SHOP DRAWING REVIEW
☒ REVIEWED AS REQUIRED BY THE DISTRIBUTION CONTRACT DOCUMENTS AND APPROVED. ONLY FOR CONFORMANCE TO THE DESIGN CONCEPT OF THE WORKS AND GENERAL COMPLIANCE WITH THE CONTRACT DOCUMENTS. ☐ REVISE AND RESUBMIT. ☐ REJECTED AS CORRECTED LISTED ABOVE. ☐ REVIEW NOT REQUIRED. THIS REVIEW DOES NOT RELIEVE THE CONTRACTOR OF HIS OBLIGATION TO FURNISH MATERIALS AND PERFORM THE WORK IN ACCORDANCE WITH THE CONTRACT DOCUMENTS. THE CONTRACTOR IS SOLELY RESPONSIBLE FOR DIMENSIONS, THE FABRICATION PROCESS AND TECHNIQUES OF CONSTRUCTION, COORDINATION OF THE WORK WITH THAT OF ALL OTHER TRADES, AND THE SATISFACTORY PERFORMANCE OF THE WORK.
Reviewed by: SSM
Date: 8/22/06
Job Number: 5501
Vermont Agency of Transportation
Structures Section
Bridge Design Section
Engineer: Yon Hsiao, Ph.D., P.E.
Engineer: Steven A. Lutz, P.E.
Bridge Rel. Engineer: Richard Sargent, P.E.
Phone: 802-828-2085

GIRDER G12U
VT 78 OVER MISSISQUOI BAY, BRIDGE NO. 2
VT 78 STA.10+970.425 TO STA.12+059.775
TOWNS OF ALBURG AND SWANTON
COUNTIES OF GRAND ISLE AND FRANKLIN
STATE OF VERMONT, AGENCY OF TRANSPORTATION

STATE CONTRACT OR REF. NO. BRF-036-1(1)
CONTRACTOR CIANBRO CORPORATION
IN CHARGE: GLIDDEN (IH) MADE BY:

GIRDER ~ G12U

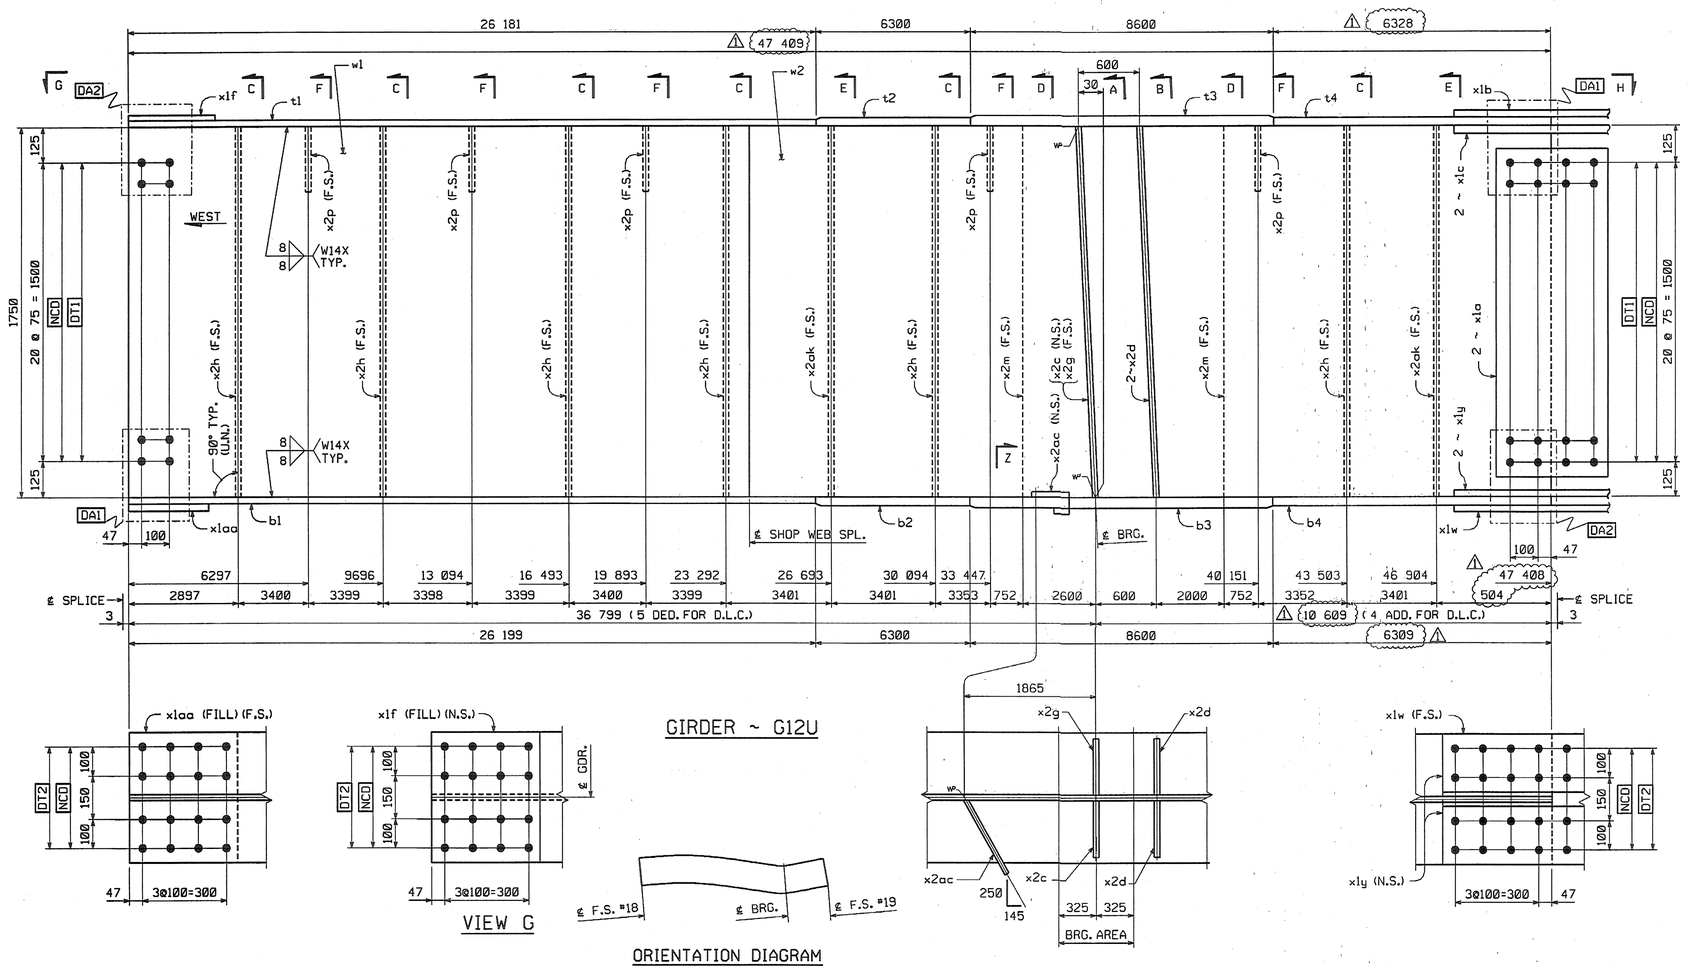
NO.	MARK	DESCRIPTION	LENGTH	REMARKS	GRP.	ITEM	SHIP. WT. KG. EA.	
ONE	G12U	GIRDER					22 350	
~~1~~	~~w1~~	~~PL 16 x 1750~~	~~23 812~~	~~(T)~~	3	4	~~5233.28~~	10420.39
1	w2	PL 16 x 1750	23 609	(T) 47408	3	2	~~5188.66~~	
1	t1	PL 22 x 450	26 181	(T)	4	20	~~2034.42~~	2034.66
1	t2	PL 32 x 450	6 300	(T)	4	15	~~712.07~~	712.15
1	t3	PL 65 x 450	~~8 601~~	(T) 8600	4	2	~~1974.67~~	
1	t4	PL 32 x 450	6 328	(T)	4	13	~~715.24~~	715.32
1	b1	PL 22 x 450	26 199	(T)	4	20	~~2035.82~~	2036.06
1	b2	PL 32 x 450	6 300	(T)	4	15	~~712.07~~	712.15
1	b3	PL 65 x 450	~~8 601~~	(T) 8600	4	2	~~1974.67~~	
1	b4	PL 32 x 450	6 309	(T)	4	14	~~713.09~~	713.17
2	x1a	PL 12 x 1600	400	(T)	6	1	~~60.28~~	120.58
1	x1b	PL 14 x 450	790	(T)	6	6	~~39.06~~	39.07
2	x1c	PL 16 x 200	790	(T)	6	5	~~19.84~~	39.69
1	x1f	PL 10 x 450	392	FILL	6	7	13.85	
1	x1w	PL 14 x 450	790	(T)	6	6	~~39.06~~	39.07
2	x1y	PL 16 x 200	790	(T)	6	5	~~19.84~~	39.69
1	x1aa	PL 10 x 450	392	FILL	6	7	13.85

1	x2c	PL 38 x 200	1 750		7	1	~~104.39~~	104.41
2	x2d	PL 38 x 200	1 750		7	1	~~104.39~~	208.81
1	x2g	PL 38 x 200	1 750		7	1	~~104.39~~	104.41
6	x2h	PL 12 x 180	1 750		7	4	~~29.67~~	178.04
2	x2m	PL 12 x 180	1 750		7	4	~~29.67~~	59.35
5	x2p	PL 14 x 180	310		7	3	~~6.13~~	30.66
1	x2ac	PL 6 x ~~115~~	301	*Vol = 79650mm³	7	5	~~4.63~~	0.62
2	x2ak	PL 12 x 180	1 750		7	4	~~29.67~~	59.35
TOTAL WEIGHT THIS SHEET:			~~22 346.3~~		kgs

NO.	REVISION	BY	DATE
1	INCREASE LENGTHS TO SATISFY REQUIREMENTS FOR LENGTH @ MEAN TEMPERATURE OF 45°F	DP	9/20/04

22 344.69 kg JMR 8-15-06

22 344.7 kg JMR 8-22-06
